MARITIME SAFETY COMMITTEE
87th session
Agenda item 26

MSC 87/26/Add.1
30 June 2010
Original: ENGLISH

**REPORT OF THE MARITIME SAFETY COMMITTEE ON ITS
EIGHTY-SEVENTH SESSION**

Attached are annexes 1 to 28 to the report of the Maritime Safety Committee on its eighty-seventh session (MSC 87/26).

3.4.2 Packing

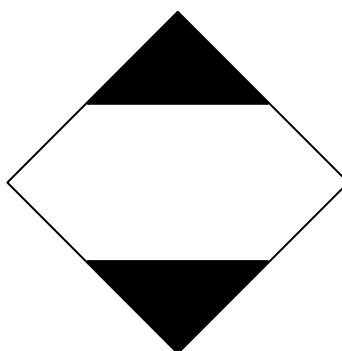
- 3.4.2.1 Add a new second sentence to read as follows: "Intermediate packagings may be used."
- 3.4.2.2 The end of the first sentence, after "with these special provisions", is replaced with the following:

"Inner packagings that are liable to break or be easily punctured, such as those made of glass, porcelain, stoneware or certain plastics, shall be placed in suitable intermediate packagings meeting the provisions of 4.1.1.1, 4.1.1.2 and 4.1.1.4 to 4.1.1.8, and be so designed that they meet the construction requirements of 6.1.4."

3.5.4 Marking of packages

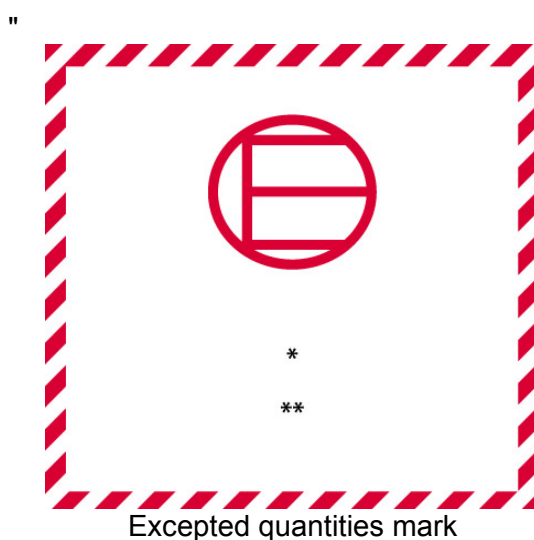
3.5.4.1 Amend the mark as follows:

Hatching and symbol of the same colour, black or red,
on white or suitable contrasting background

6.3.5.4 Puncture test

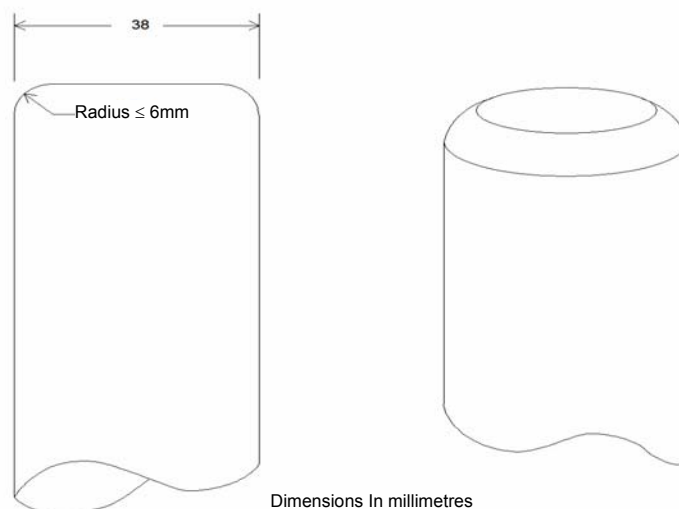
6.3.5.4.1 In the second sentence, after "not exceeding 6 mm" insert "(see below)".
